July 10, 2015

01763 Version 1

I-MID Displays “Camera Too Hot” Message

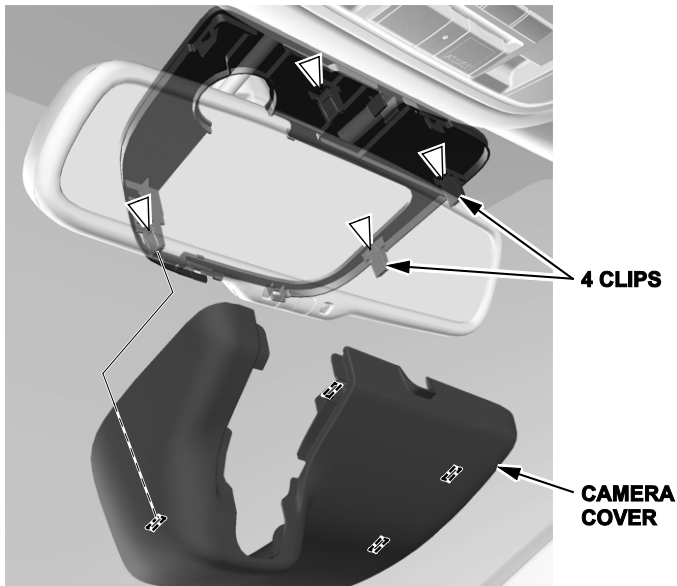
1. Remove the camera cover lid.

2. Remove the camera cover.

3. Install the new camera cover in the reverse order of removal.

Replace the camera cover with a new one. The new cover is vented to provide better airflow around the camera.
